Docket Item # 5
BAR CASE # 2011-0226

BAR Meeting
September 7, 2011

ISSUE: Alterations (new window)
APPLICANT: James Pastorick and Kim Green
LOCATION: 811 Duke Street
ZONE: RM/Residential

Figure 3. Window details.

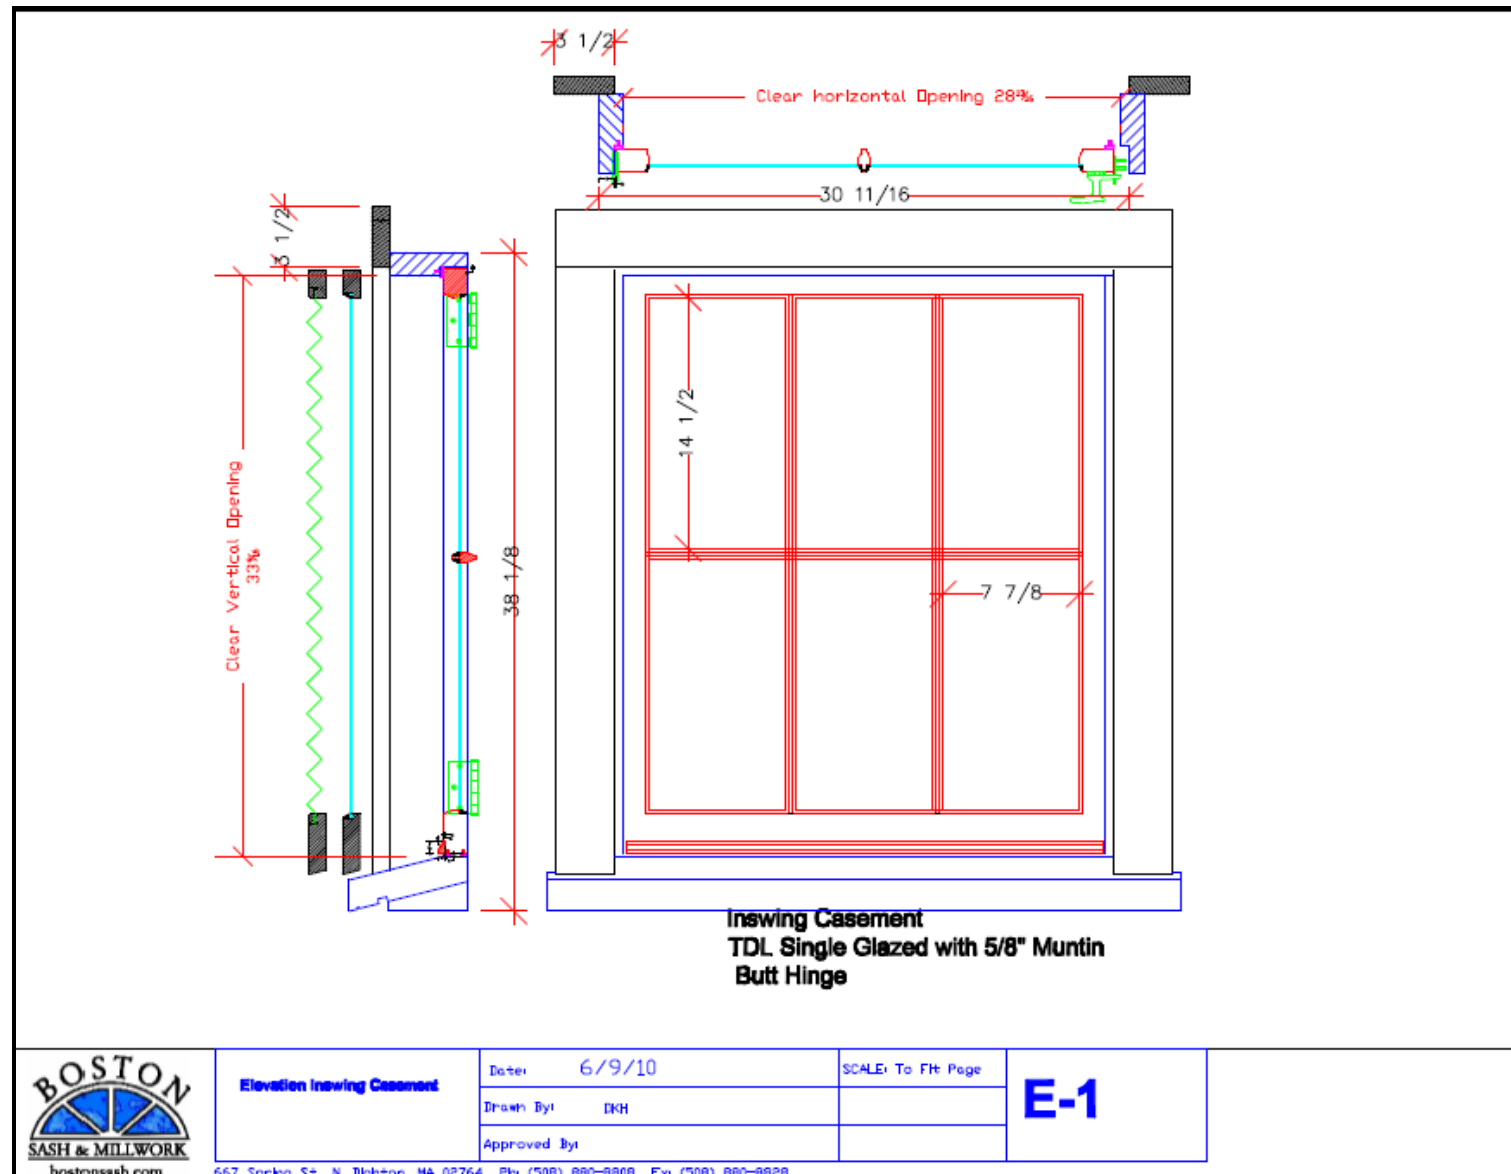
Staff has no objection to the proposed new window on the front elevation, as this very high quality wood window is in compliance with the *Alexandria Replacement Window Performance Specifications* in Board's new Window Policy. There are a number of other windows on the raised basement levels of historic townhouses in the 800 block of Duke Street, some appear to be original and others are clearly later additions. The proposed window is aligned with the windows above and the muntin pattern is in proportion with those in the main body of the house. In addition, because the face brick on the raised basement does not appear to be original, no historic material will be lost.

Staff recommends approval of the application as submitted.
